City of Green Bay Planning Department Response to Walmart Conceptual Plan

Site Design

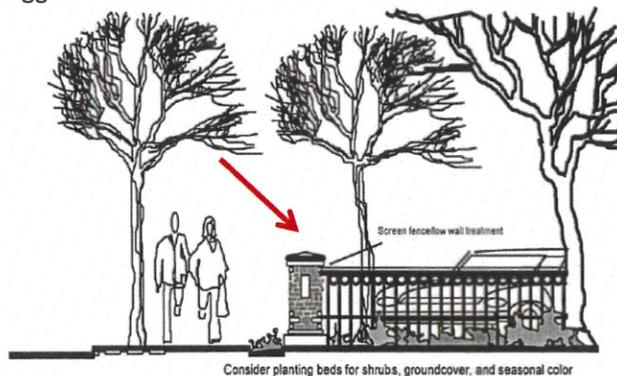
1. Address the expanse of surface parking and lack of building density by adding structural edges. (Suggestion: low wall and decorative fence softened with landscaping)

2. Reduce the number of access points onto Kellogg. The Zoning Code requires more separation between driveways, so some internal parking lot circulation would need to be added.

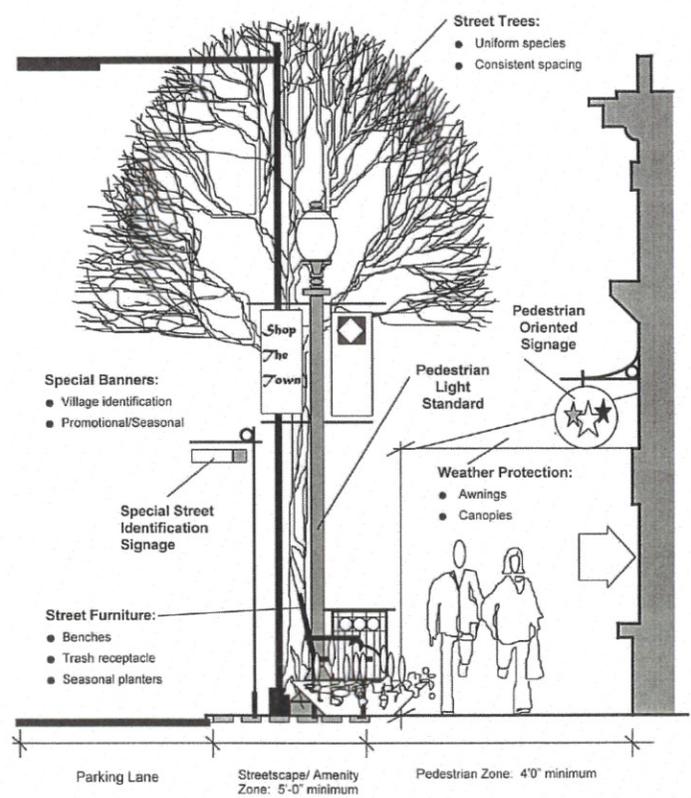
3. Add lighting and landscaping (where appropriate) that are pedestrian scaled, especially along the Elmore access drive, along Kellogg and Broadway, and along the pedestrian access aisle in the middle of the parking lot.
4. Design the access drive aligned with Elmore Street as a streetscape with clear separation between the vehicle thoroughfare and the pedestrian zone, clearly marked crosswalks, and a "Main Street" feel overall.

Architecture

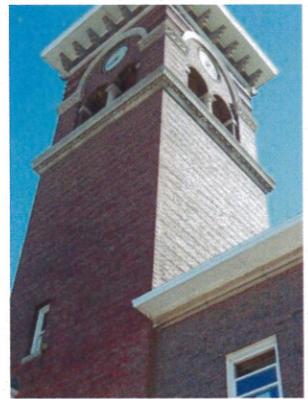
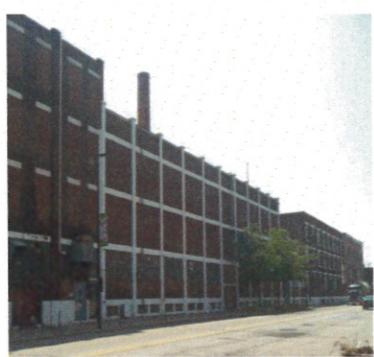
1. Relate the building to the surroundings of Larsen Green. Suggestions:
 - a. Incorporate a design element from the Larsen Cannery
 - b. Incorporate a design element tied to the railroad or train station
 - c. Incorporate similar features as Titletown at Larsen redevelopment like the external truss
 - d. Use brick
 - e. Create a tower element

2. Add transparency and activation along Broadway. Suggestions:
 - a. Spandrel glass
 - b. Arcade
 - c. Atrium
 - d. Awnings
 - e. Transit shelter
